Meeting name	Supplier Volume Allocation Group (SVG)
Date of meeting	3 November 2009
Paper title	Change Proposal Progression
Purpose of paper	For Decision
Synopsis	This paper provides: <ul style="list-style-type: none">• 5 Change Proposals (CP1307, CP1309, CP1310, CP1311, CP1312) for decision; and• details of all Open Draft Change Proposals (DCPs) and Change Proposals (CPs).

2 Summary of Change Proposals for progression

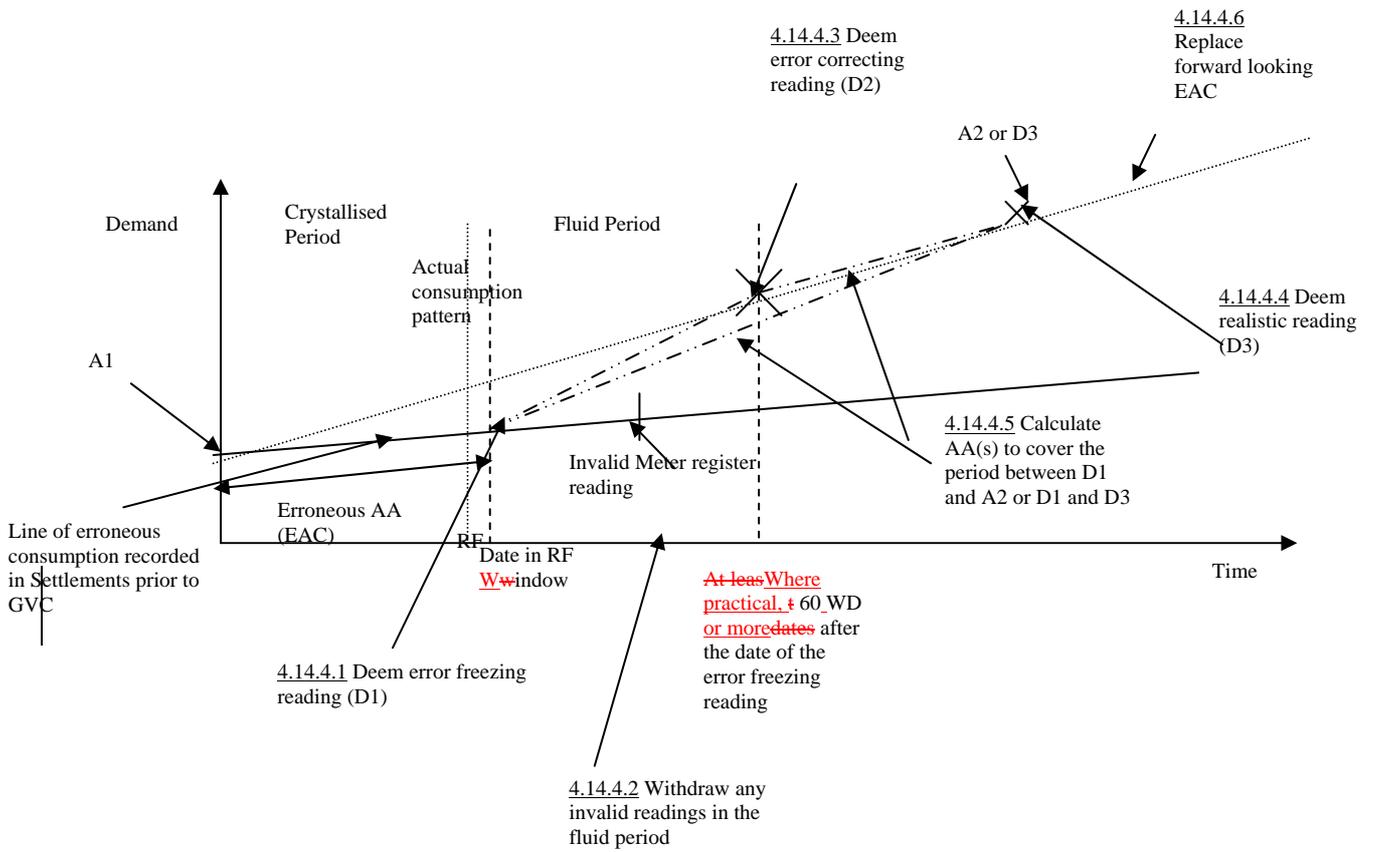
GVC is an optional requirement for the Supplier; however the NHHDC must be able to carry out GVC if required to by the Supplier. GVC shall be carried out by the NHHDC when this has been agreed with the Supplier, and when the use of GVC meets the criteria described above. Where the NHHDC receives a request from the Supplier to apply GVC, which does not meet the criteria described above, it should be referred back to the Supplier with supporting rationale for why the NHHDC does not consider that GVC is appropriate. The NHHDC may also initiate the use of GVC, although only with the agreement of the relevant Supplier or Suppliers. Such approval can be obtained on a per-instance or delegated authority basis, as agreed with the Supplier.

The NHHDC may identify that ~~Gross-Volume-Correction~~ should be carried out if the EAC is above BSCCo monitoring levels or where reads are consistently failing validation but in line with each other.

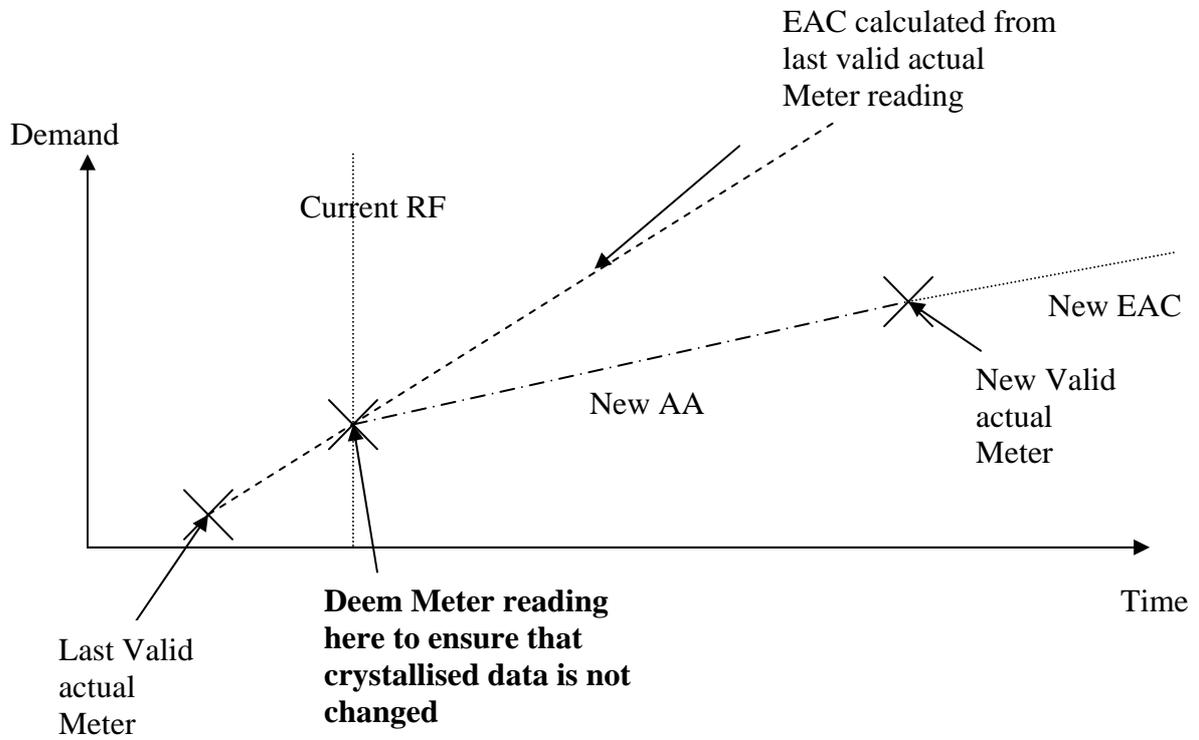
- e) At RF to ensure that crystallised data is not changed post the RF.

When a Meter has been read and the RF for the date of the previous Meter register reading has taken place, a Meter reading shall be deemed for the earliest practical Settlement Day for which the RF has not yet taken place over the Deemed Meter Advance Period starting from the date of the last crystallised valid actual Meter reading and ending on the earliest practical Settlement Day for which the RF has not yet taken place. The Deemed Meter Reading should be calculated using the last crystallised valid actual read taken and a Deemed Meter Advance calculated using the last EAC (i.e. the EAC used in the RF).

4.14.3 Use of Gross Volume Correction

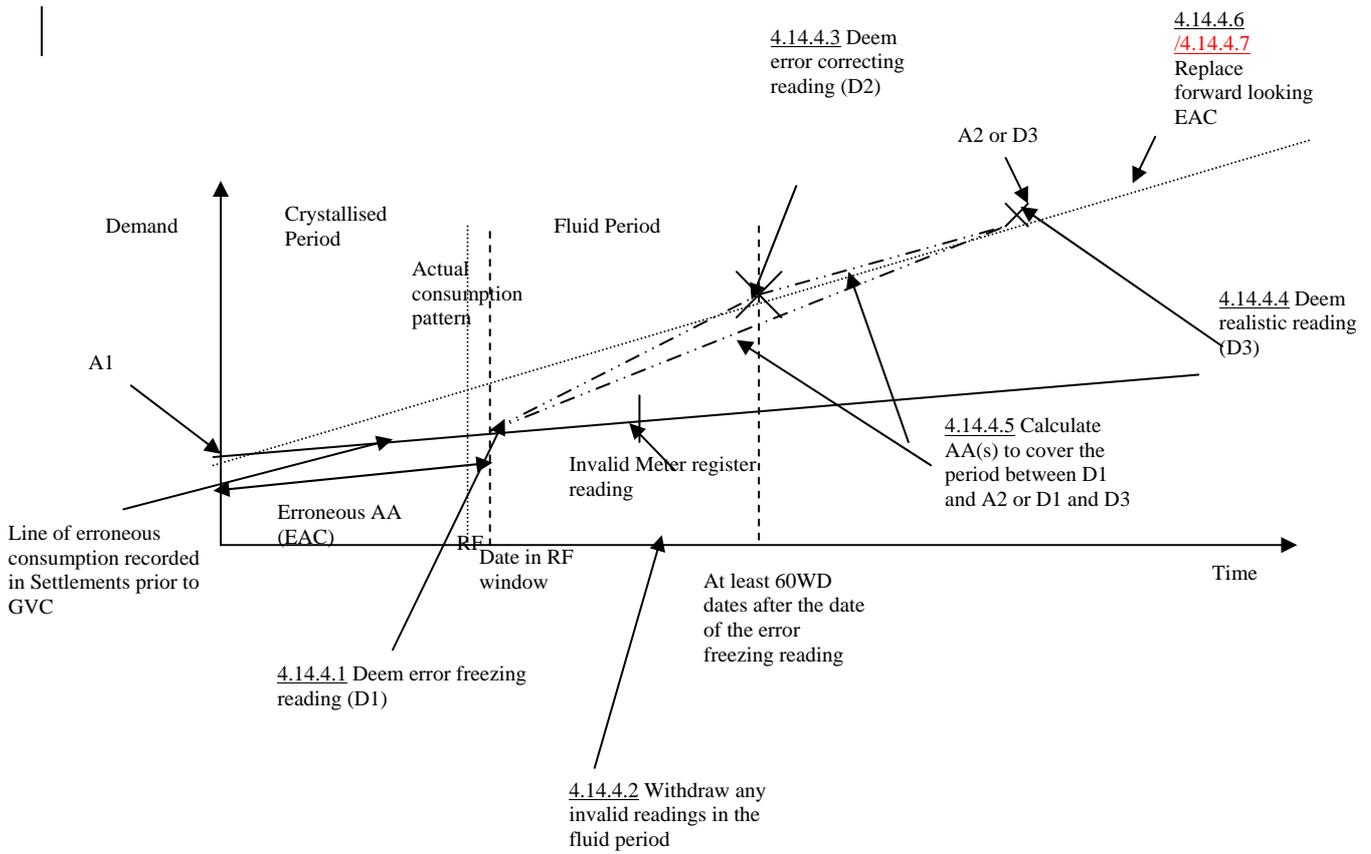
GVC is an optional requirement for the Supplier, however the NHHDC must be able to carry out GVC if required to by the Supplier. GVC shall be carried out by the NHHDC when this has been agreed with the Supplier.

The NHHDC may identify that Gross Volume Correction should be carried out if the EAC is above BSCCo monitoring levels or where reads are consistently failing validation but in line with each other.

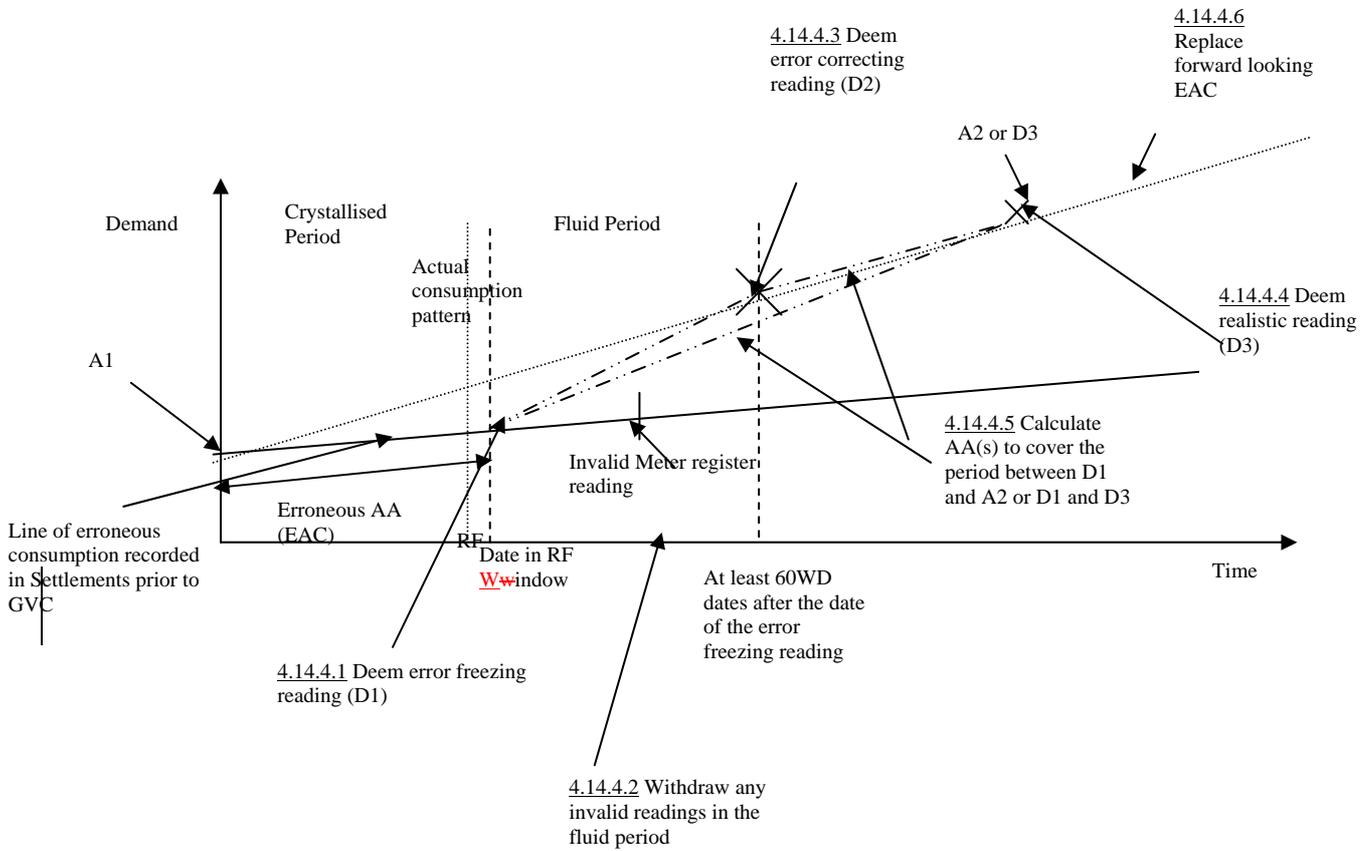
The NHHDC may identify that ~~Gross Volume Correction~~ should be carried out if the EAC is above BSCCo monitoring levels or where reads are consistently failing validation but in line with each other.

Where an AA or EAC is subject to an authorised Trading Dispute and the Effective From Settlement Date is after the latest Settlement Date which has been subject to a PFSR, the AA or EAC may be withdrawn without the need to apply GVC. GVC can be applied to any AA or EAC, irrespective of whether these are subject to a Trading Dispute, but error freezing readings can only be applied in the RF Window. Error freezing readings should not be applied at the latest PFSR.
